Kansas Department of Agriculture
 Division of Water Resources
CHANGE: P/U WORKSHEET

SUMMARY ORDER APPROVING APPLICATION FOR CHANGE AND IMPOSING CONDITIONS

Change in Place of Use Application Map

Re: Place of Use Change Application, File No. 48088

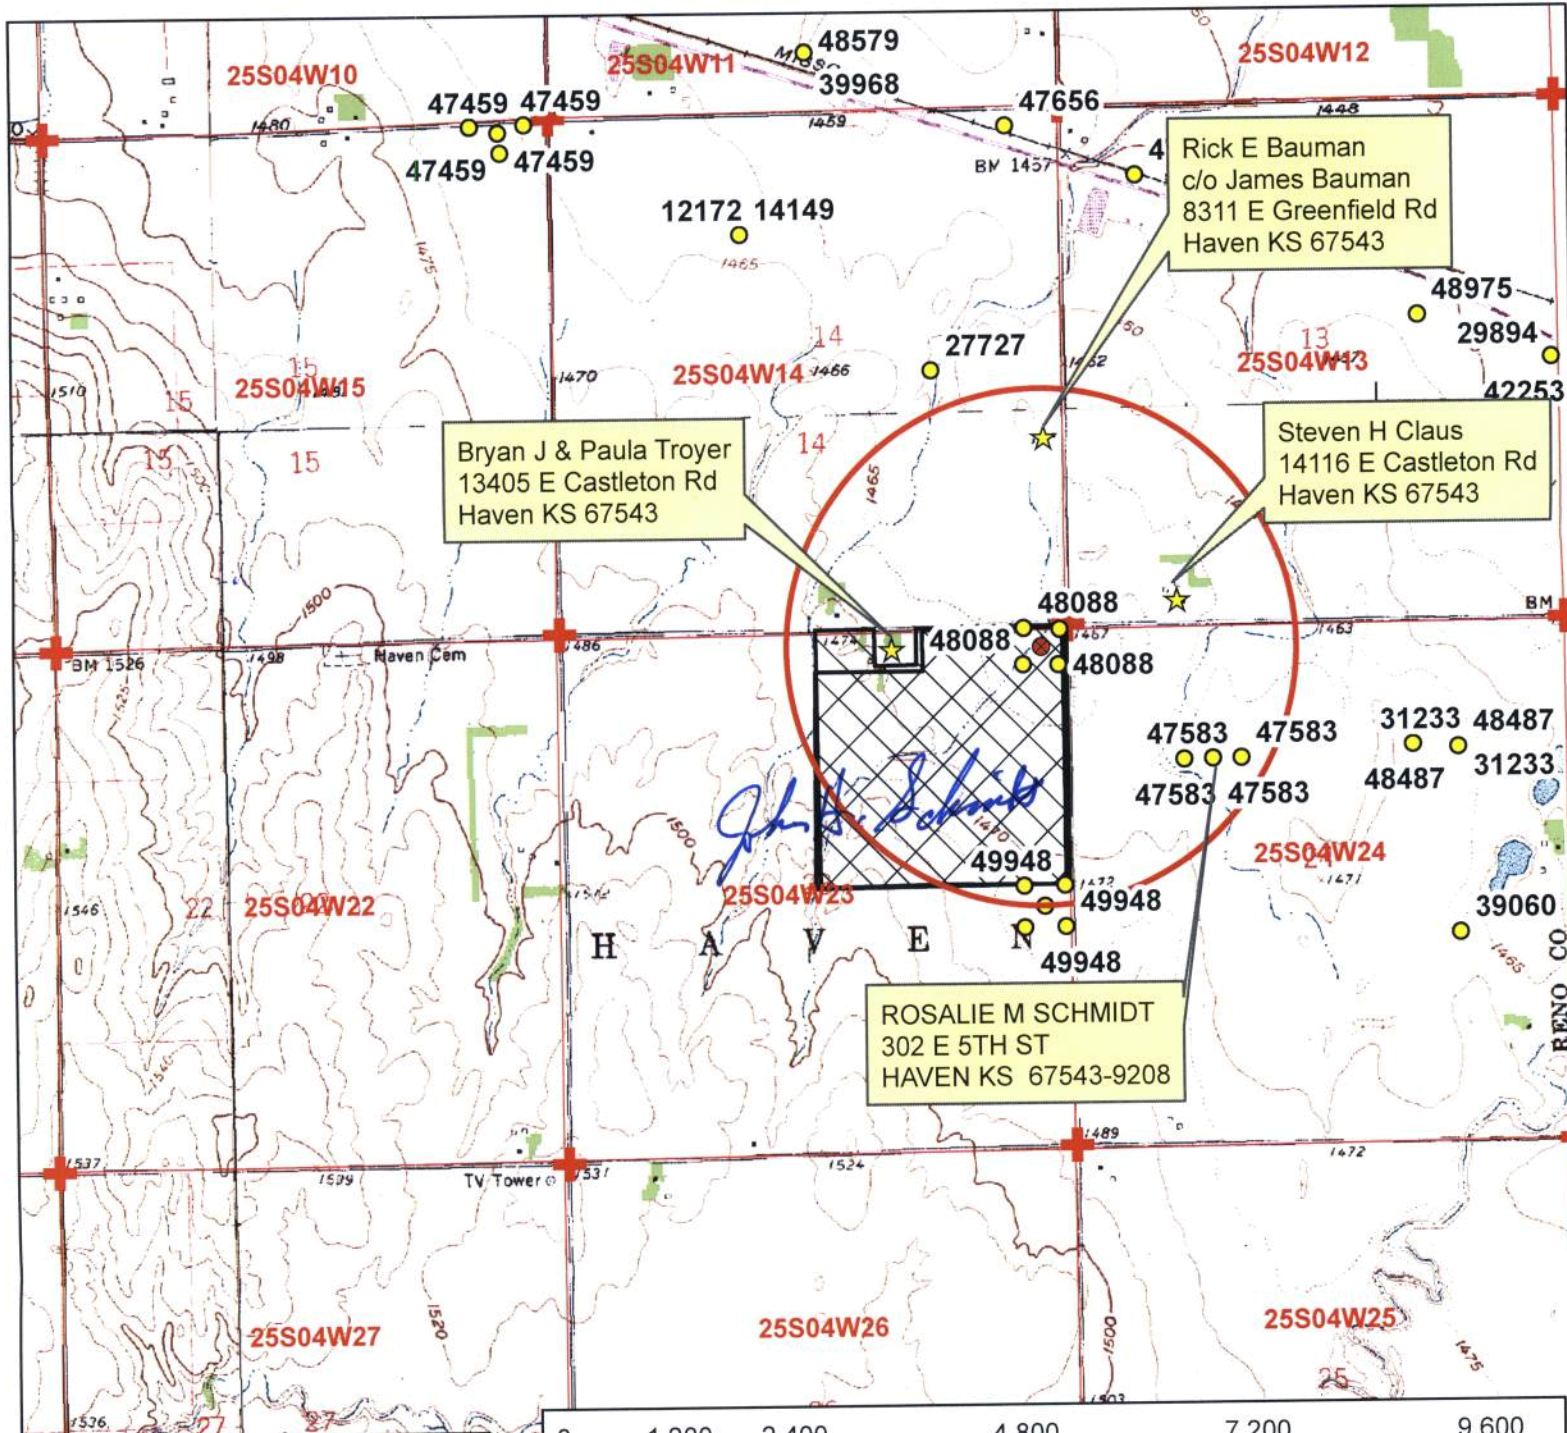
7. The changes herein are desired for the following reasons?
 (please be specific) Modify the place of use to cover
unauthorized acres as well as potential new acres for
expansion.

The change application proposes to increase the place of use from 140 acres to 150.5 acres. The proposed place of use results in a water to land ratio of approximately 1.36 acre-feet per acre.

Change in place of use application submitted by John Schmidt to increase the place of use from 146 acres to 150.5 acres in Reno County.

Application requests a 4.5 acre (3.1%) increase of the currently authorized and base acres of 146 acres to cover unauthorized acres and possible future place of use

Item 13: 204.4 AF / 150.5 acres = 1.36 AF/A

The District's review found that the change application complies with the Revised Aquifer Management program approved by the Chief Engineer and with the District's Rules and Regulations K.A.R. 5-22-1 through 5-22-17. Based upon the review, the application is recommended for approval by the Equus Beds Groundwater Management District No. 2.

Recommend approval, complies with K.A.R. 5-22-1 through 5-22-17
